3.5.4 Water Resources Comments and Responses

Figure 3.5-11: Distance Drawdown Plot for Well HH
 Lost Lake Resort
 Town of Forestburgh, Sullivan County, NY
 Source: Advantage Engineers, 9/13/10

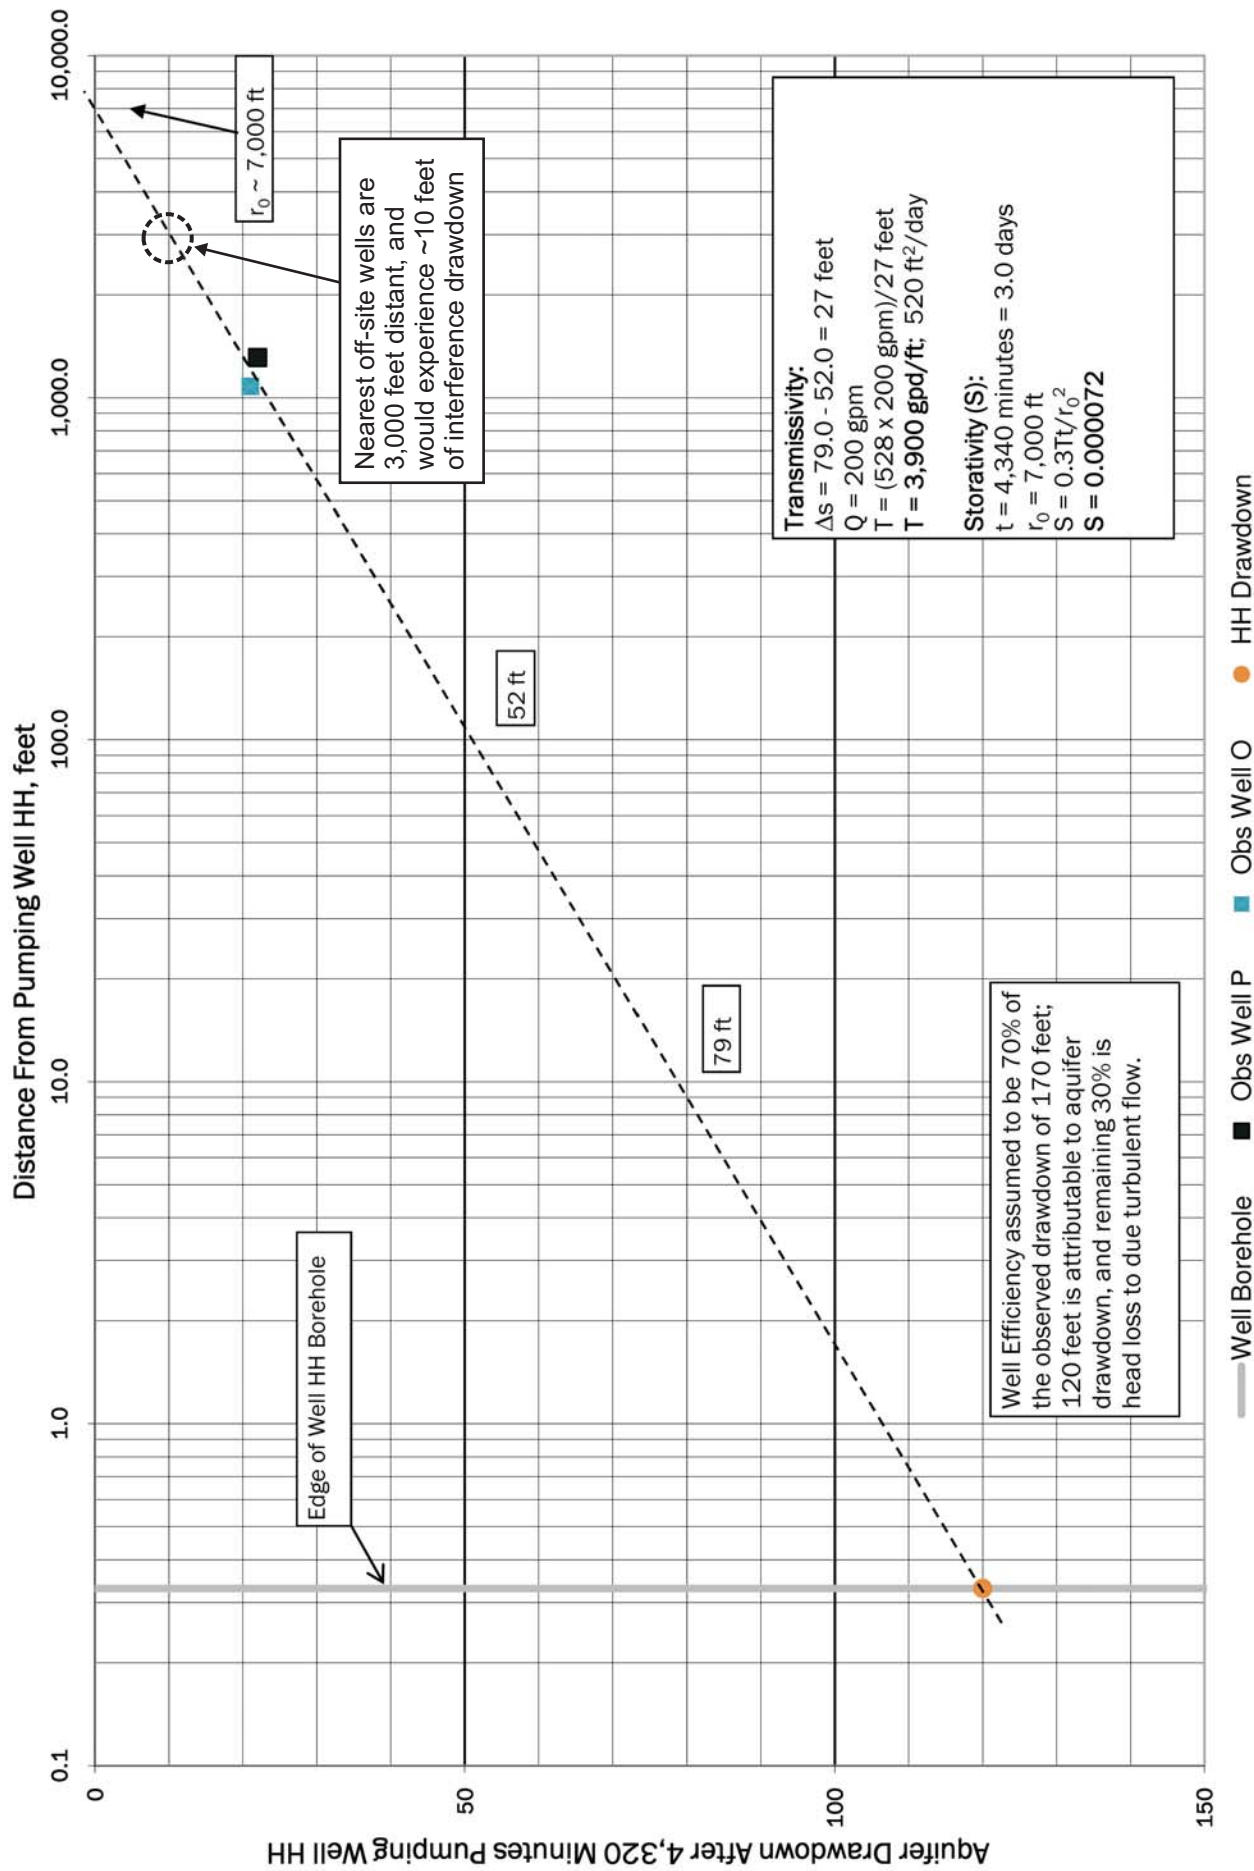
Comment 3.5-11 (Letter 4, CT Male Associates, July 1, 2010): Water Supply Report: Distance Drawdown graphs would be helpful to understand the impact upon non-pumping monitoring wells during the pumping tests of the selected production wells. The discussion on page 7 of Appendix M1 is confusing. Why are the recorded drawdown in wells CC, P and O during the pump testing of well HH not presented or discussed? Nearly 100 feet of drawdown was experienced at well CC during the pumping of well HH and approximately 20 feet at wells CC and P. The cumulative effects of multiple pumping wells operating at the same time should be evaluated to determine if the pumping rates indicated in the report are in fact long term safe yields for the production wells to be used by the community water system.

Comment 3.5-15 (Letter 4, CT Male Associates, July 1, 2010): The potential impact of groundwater withdrawal to existing off-site private wells needs to be more fully addressed. The conclusions state that future use of the wells will not adversely impact off-site private wells, based on the monitoring well data collected during these tests. This is a stretch in that none of the off-site wells were the subject of monitoring during the pump tests, and as indicated elsewhere in the report, there is no way to know if the water bearing fractures in the test wells are hydraulically connected to the fractures in the private water wells. According to Section 8.0 of Appendix M1, drawdown levels at monitoring wells a third to over one-half mile exhibited drawdown levels of 2.2 to 5.5 feet. Typically, regardless of whether or not in an unconsolidated or bedrock aquifer system, the level of drawdown increases as the distance between the pumping well and monitoring well decreases. Without knowing the distance between the off-site private wells to the pumping wells, as well as the depth of the private wells and depth of the pump settings, this conclusion relative to off-site wells is unsubstantiated.

Response 3.5-11: *The apparently excessive drawdown at well CC during the pumping of HH is because the wells are within 15 feet of each other, and it represents an atypical aquifer response because the wells share common water-bearing zones. That response is not useful for predicting aquifer drawdown at greater distances.*

In order to evaluate the general drawdown effects, a distance drawdown plot is presented (Figure 3.5-11 at the end of this section) that illustrates the observation well data from the aquifer test for well HH. The plot shows the drawdown observed at the end of the test, when any further aquifer drawdown would be negligible because the pumping

wells had reached stabilization. The plot is useful for evaluating aquifer impacts to other pumping wells and off-site private wells in the area, including two on-site observation wells as no off-site wells were made available to monitor. Well HH is plotted because the aquifer interference was greater than what occurred during the test of wells P, O, and DD and therefore it represents a more conservative, worst case approach.

The plot indicates that aquifer drawdown effects could extend a substantial distance from the pumping well, which in this instance is a projection of approximately 7,000 feet. (It is very unlikely that aquifer drawdown effects could actually propagate that far from any well at the site, due to anisotropy, friction effects, etc.). This response is typical for a bedrock aquifer under confined conditions. The nearest production well is Well O, at a distance of approximately 1,100 feet, where interference drawdown of about 21 feet occurred. Drawdown is additive, so an additional 21 feet of drawdown at Well O would not be a significant effect, since the available water column at Well O after that well reached stabilization is more than adequate to account for the interference. Well P is located a similar distance from Well HH, and had a similar drawdown interference (22 feet), but also has a large available water column after reaching stabilization, so no substantial decline to Well P's sustainable yield is expected. A smaller effect (i.e., less than 22 feet) at well HH would be expected from simultaneous pumping at wells O and P, and the available water column would also be more than adequate to account for the additional interference.

Response 3.5-15: The nearest off-site wells relative to well HH lie approximately 3,000 feet away, along Cold Spring Road towards the southeast. As illustrated in FEIS Figure 3.5-11 distance drawdown plot for well HH, the projected drawdown at a distance of 3,000 feet is 10 feet, which would probably not result in any discernible change to the production of a typical residential well. This assumes that the water bearing zones at the off-site wells are in some hydraulic communication with the site production wells; this may not be the case since the on-site wells obtain most of their groundwater from very deep zones, and typically domestic wells are not constructed to such depths. As noted in the comment, without the actual well depths and pump settings of off-site wells, the

extent of potential impact to off-site domestic wells from future use of the production wells cannot be concluded more certainly. However, unless a neighboring well owner consents to monitoring during a pumping test, the Applicant is unable to provide a more conclusive analysis than the use of the distance drawdown plot for well HH.
